ADDENDUM NUMBER THREE
TO THE CONTRACT DOCUMENTS FOR CONSTRUCTION OF
ORANGE BEACH RECREATION COMPLEX
NEW BASEBALL/SOFTBALL FIELD RENOVATIONS AT ORANGE BEACH SPORTSPLEX
CITY OF ORANGE BEACH

This addendum forms a part of the Contract Documents and modifies the Bid Documents dated May 4, 2020.

This Addendum consists of three (3) page Addendum, one (1) general documents, one (1) Specification & thirteen (13) full-size sheets.

**CONCOURSE LEVEL PLANS -
 ANNOTATIONS**
 A102

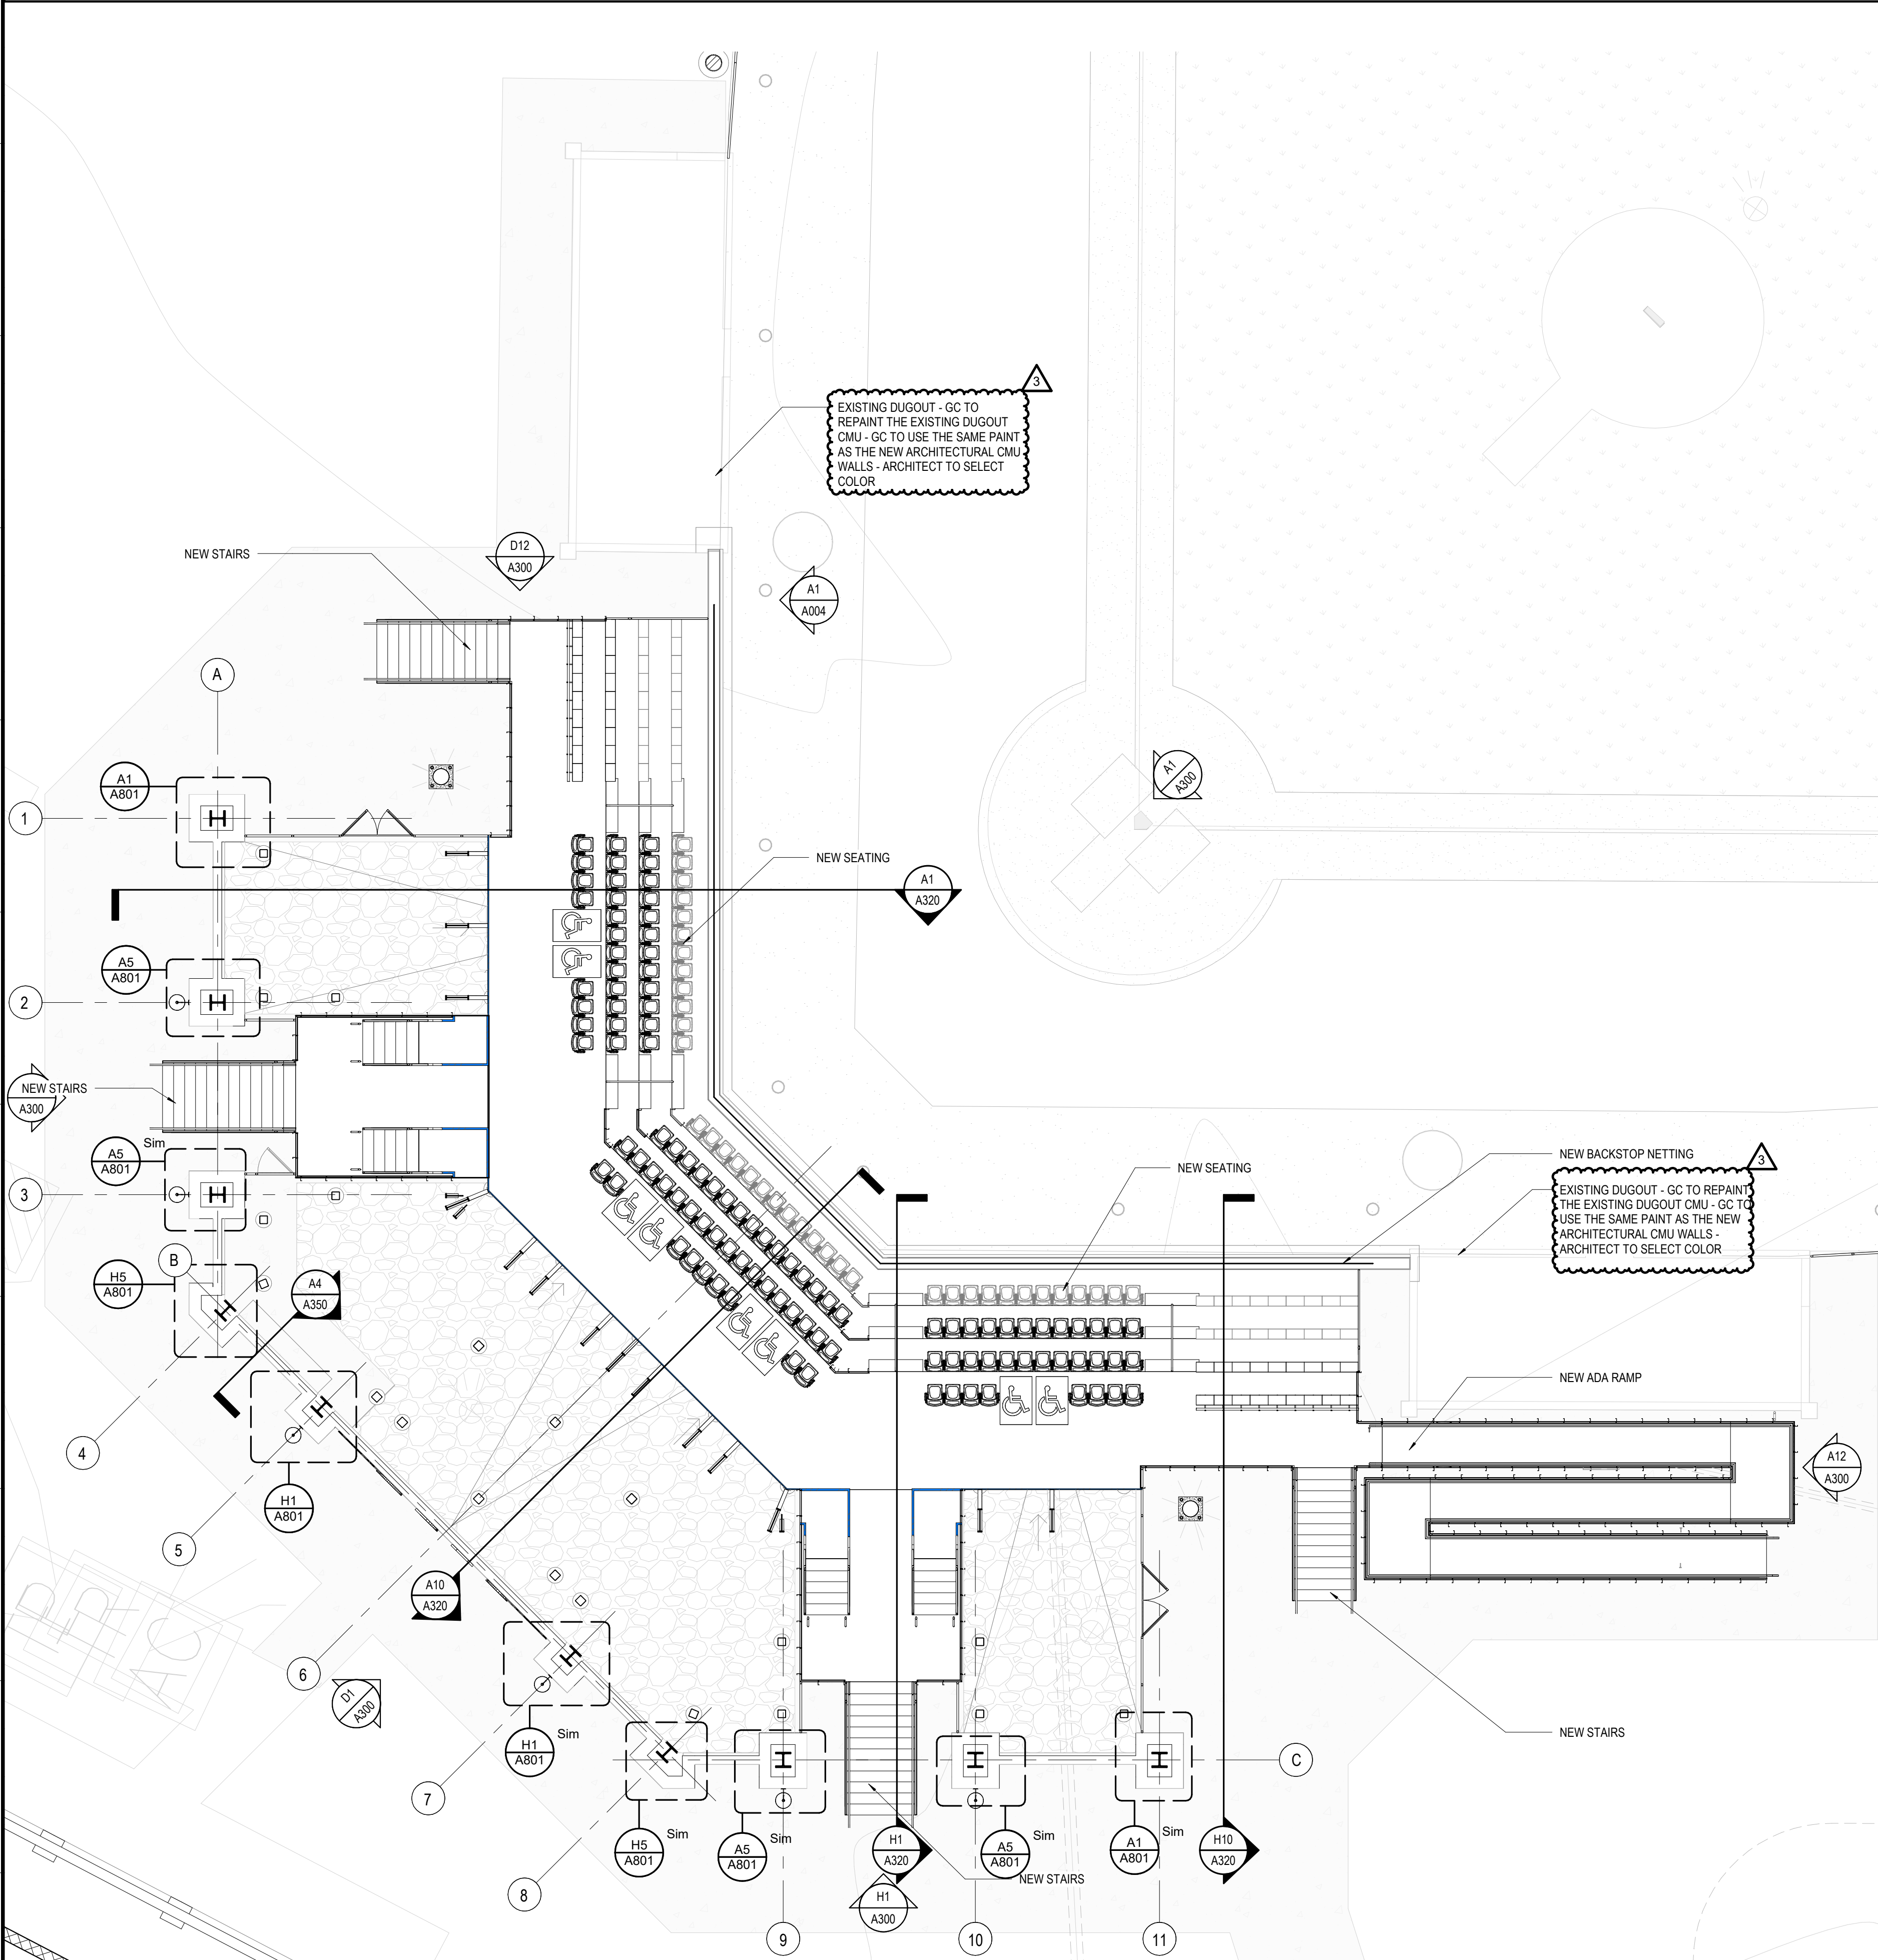
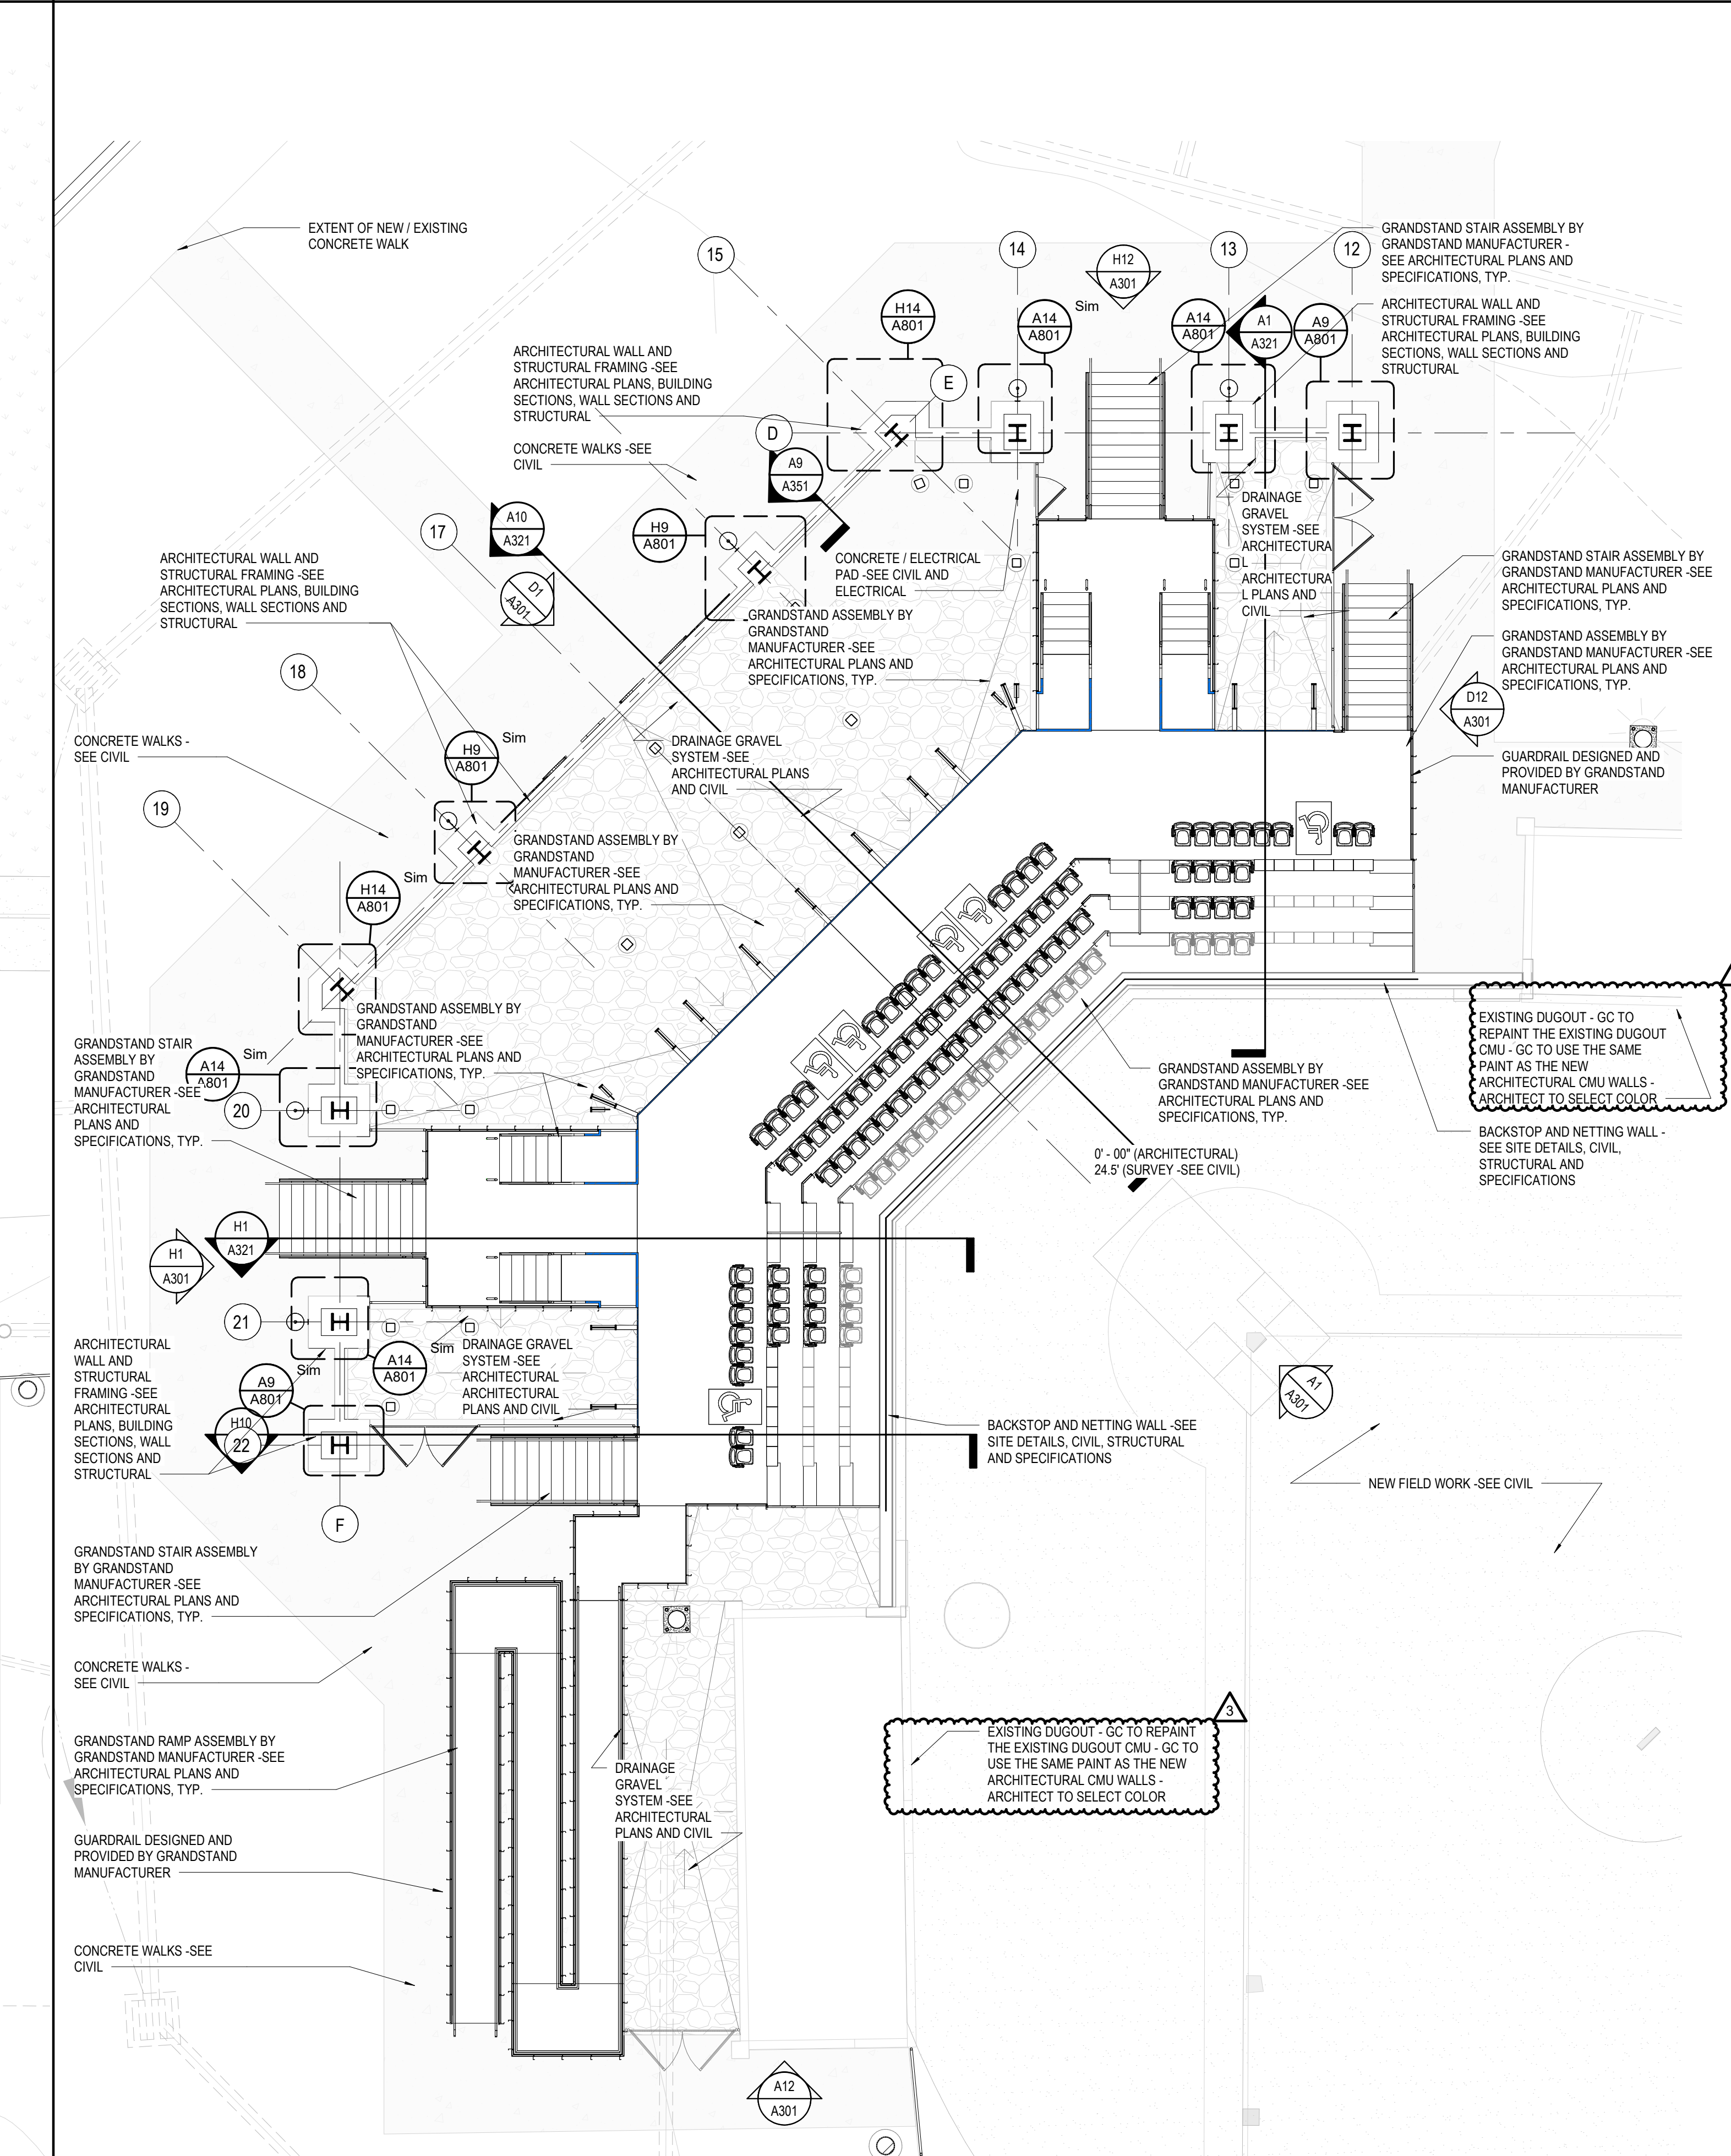
ITEM 10 SHEET A102 – CONCOURSE LEVEL PLANS - ANNOTATIONS

1. Revised Notes for existing dugout – existing dugout cmu to be repainted by GC.
